SUBJECT: Request for Additional Information Regarding
Extended Power Uprate
Grand Gulf Nuclear Station, Unit 1
Docket No. 50-416
License No. NPF-29

Grand Gulf Nuclear Station Extended Power Uprate

Response to Request for Additional Information

Steam Generator and Chemical Engineering Branch

Figure 1-1
GGNS Spent Fuel Pool Boraflex Panel Cumulative Dose Distribution

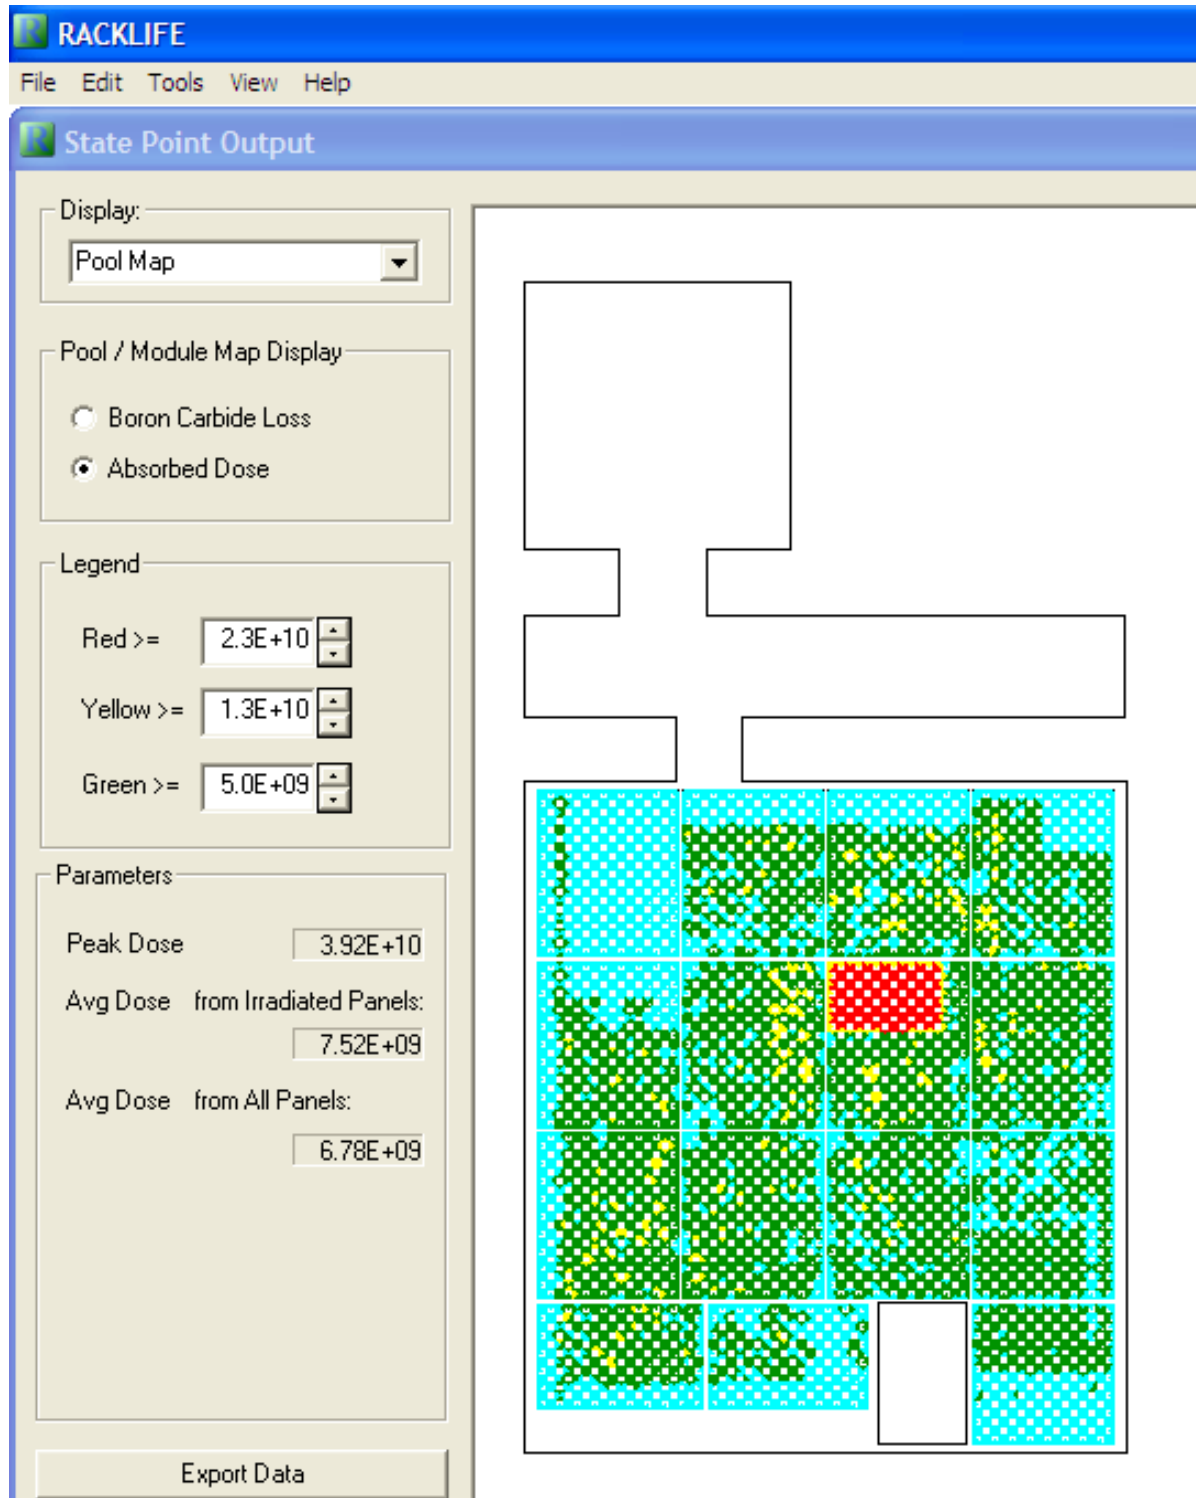
Based on industry operating experience, degradation of Boraflex panels occur in a much less uniform configuration than is shown in the spent fuel pool map provided in your letter dated March 9, 2011. That map shows that Region II racks (the racks that are degraded beyond a usable condition) are located together in the center of the pool. Please provide a map of the spent fuel pool which shows the cumulative dose to each panel in the pool. Also, discuss why Region II cells would be located in one specific area of the pool, and other cells outside of that area would not experience similar degradation after housing recently discharged fuel.

A map of the GGNS spent fuel pool (SFP) is provided in Figure 1-1. As depicted in the legend, the cells that are red have a cumulative dose greater than or equal to 2.3×10^{10} rads; those that are yellow have a cumulative dose less than 2.3×10^{10} rads and greater than or equal to 1.3×10^{10} rads; those that are dark green have a cumulative dose less than 1.3×10^{10} rads and greater than or equal to 5.9×10^9 rads; and those that are light blue have a cumulative dose less than 5.9×10^9 rads. As described in the March 9, 2011 response, Region II cells are those that have reached a cumulative dose of 2.3×10^{10} rads.

Region II is a discrete area due to freshly discharged high dose rate fuel that was placed in the current Region II locations in support of the Blackness test campaigns. This fuel remained in these locations for approximately one year. These high dose fuel assemblies were replaced with freshly discharged fuel in subsequent cycles. Other areas of the pool have been typically loaded with a single assembly that has remained in that location. Since a large fraction of the dose emitted by a discharged fuel assembly occurs during the first year, the Region II area leads the balance of the pool. Recent SFP loading patterns have been established to distribute discharged fuel assemblies to minimize the cumulative dose to Region I Boraflex panels, thereby limiting the number of Boraflex panels that exceed the dose threshold of 2.3×10^{10} rads.
